1963 - 1982 Corvette: Chevrolet Service News: Rear Spring Removal Service Update

Subject: Rear Spring Removal

Model and Year: 1968 Corvette

Date: August 1968

Fig. 6—Removing Corvette Rear Spring

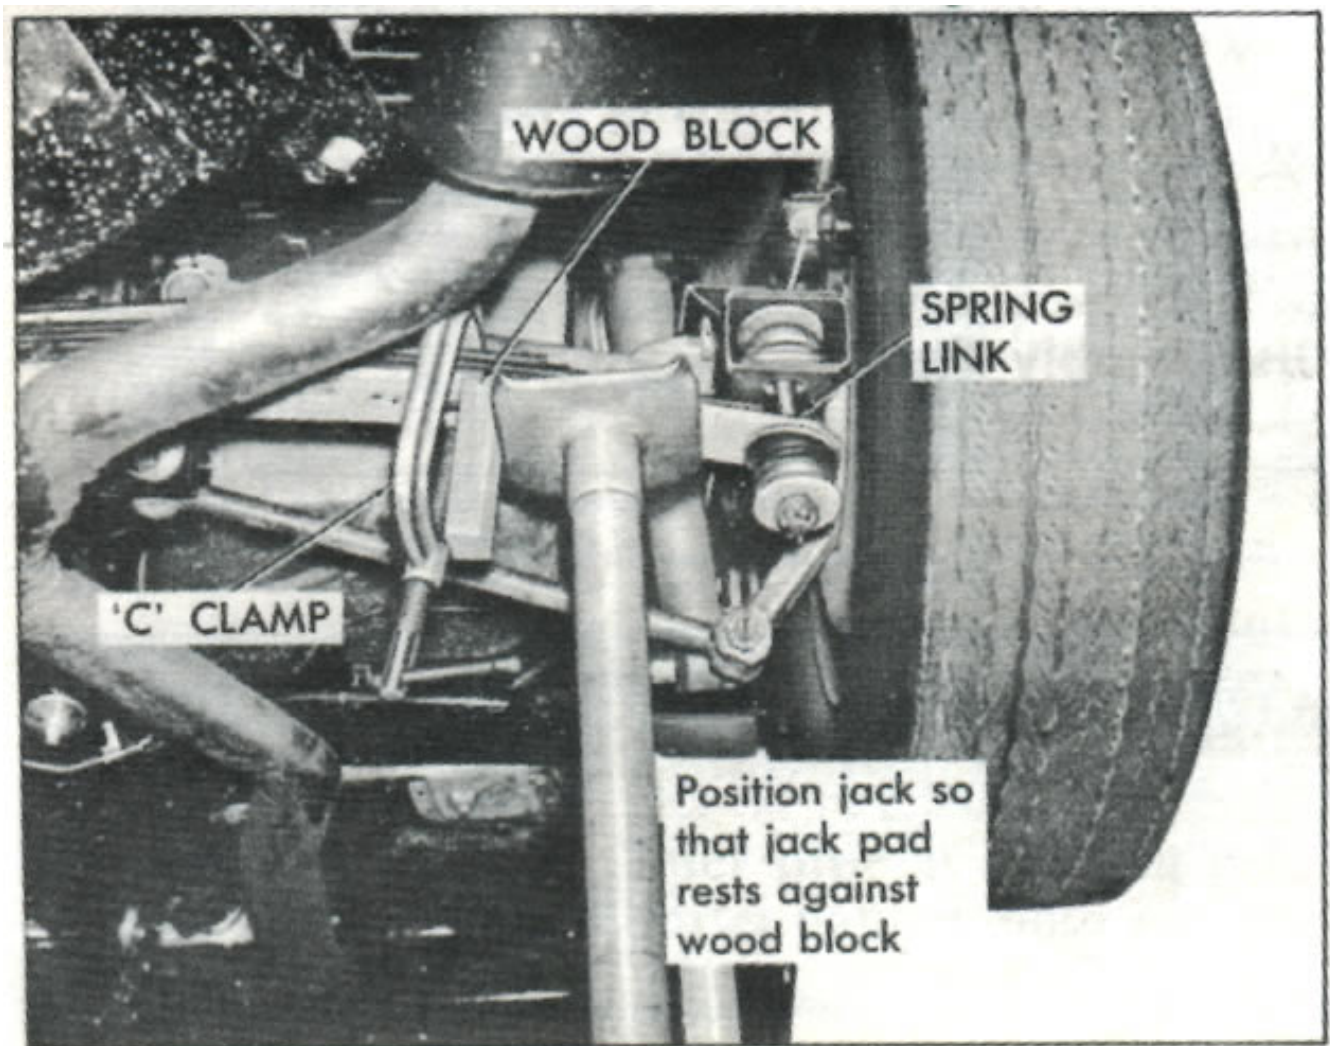
Revise the procedure appearing on page 4-20 of the 1968 Passenger Car Chassis Service Manual covering Corvette Rear Spring Removal as follows:

Removal (Reference Fig. 6)

1. Raise rear of vehicle at frame.
2. Install "C" clamp on spring approximately 9" from one end. Tighten securely.
3. Place floor jack under spring with lifting pad of jack inboard of link bolt near the "C" clamp. Place a suitable piece of wood between jack pad and "C" clamp screw. *NOTE - The "C" clamp is merely acting as a 'stop' so that the jack won't slip when the spring is released. The wood block is used to protect the "C" clamp threads from being distorted due to contact with the jack pad.*
4. Raise jack until all load is off link. Remove link cotter key and link nut. Remove cushion.

5. Carefully lower jack until spring tension is released.
6. Repeat steps 2-5 for other side.
7. Remove four bolts and washers securing spring center clamp plate (reference Fig. 51 in Manual).
8. Drop spring and slide out from under vehicle (reference Fig. 51 in Manual).
9. To install, reverse Removal steps 1-8.
